# Extinction ratio in DR links (comment 199)

Piers Dawe

NVIDIA

# Average power vs. OMA map

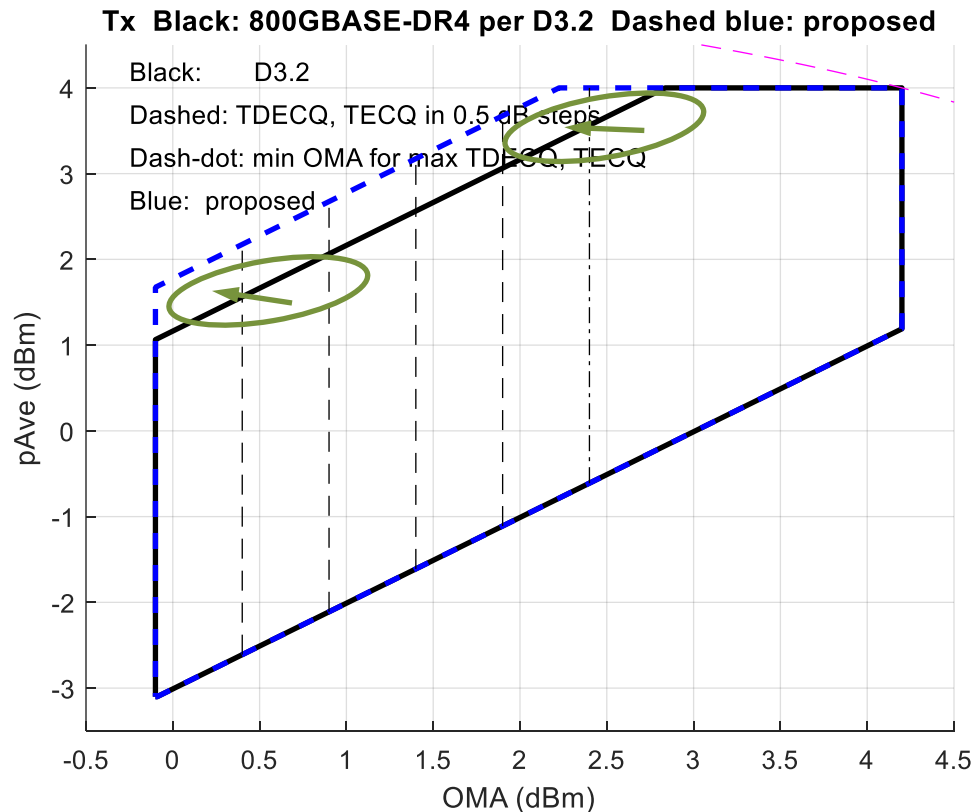
- We can reduce the limit from 3.5 dB to 3 dB for a cost of <0.2 dB
- This is a very good trade for the transmitter

- Changing the min extinction ratio from 3.5 dB (black) to 3 dB (blue). Dashed and dash-dotted ECQ lines don't change
- Example areas of interest in green
- Thin magenta line is locus of constant power in 3s, showing that receiver is not exposed to more power in 3s by the change

# Why not like 100GBASE-DR and dawe\_3dj\_01\_2607 option 1?

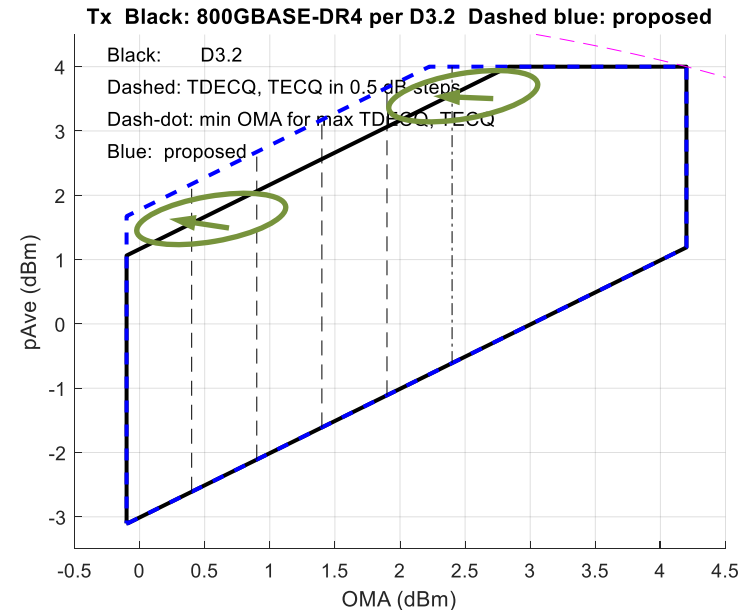
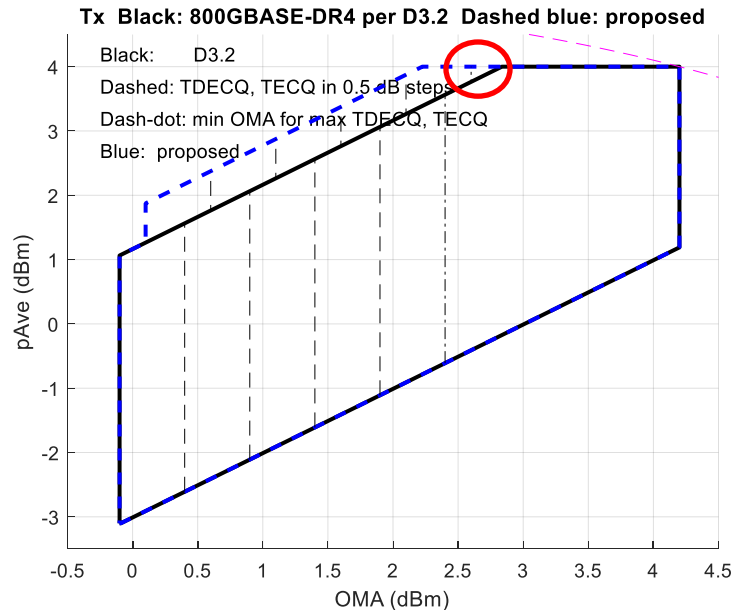
- Left: previous option 1
- (Could be made to work with increased pAve)

Right: previous option 2 = this proposal

This proposal provides better relief for the transmitter with minimal impact on the receiver

Both proposals have no impact on the cabling
